# **FIRE SAFETY INSPECTION REPORT**

**YASIN KNITTEX IND. LTD.  
SOUTH PANISHAIL, ZIRANI BAZAR, B.K.S.P,  
GAZIPUR, BANGLADESH**

**ACCORD**  
on Fire and Building Safety in Bangladesh

April 19, 2014

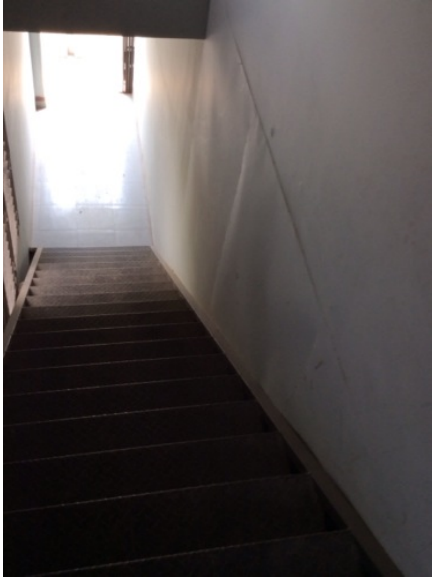
F-4	Fire Rated Construction	Unsealed penetrations and openings are located in the northern exit stair enclosure on the mezzanine floor.	Seal all penetrations and openings in exit stair enclosure walls to maintain the fire separation.	Within 3 months
-----	-------------------------	---	---	-----------------

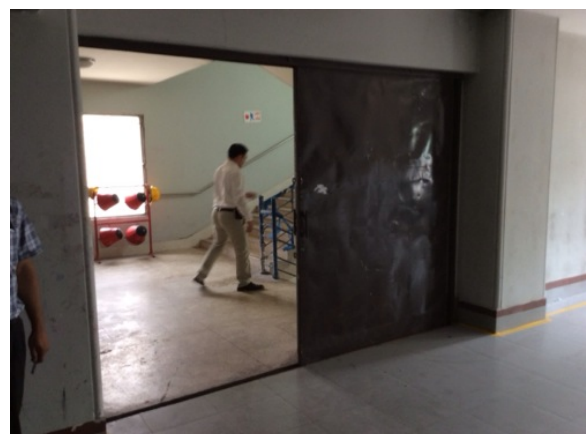
F-9	Egress	Storage was located in the northern exit stair enclosure on the 7th, 5th and ground floor.  Storage was also located inside the exit stair enclosures of other buildings in the complex.	Remove all storage from exit stairs and egress paths.	Immediate
-----	--------	--	---	-----------
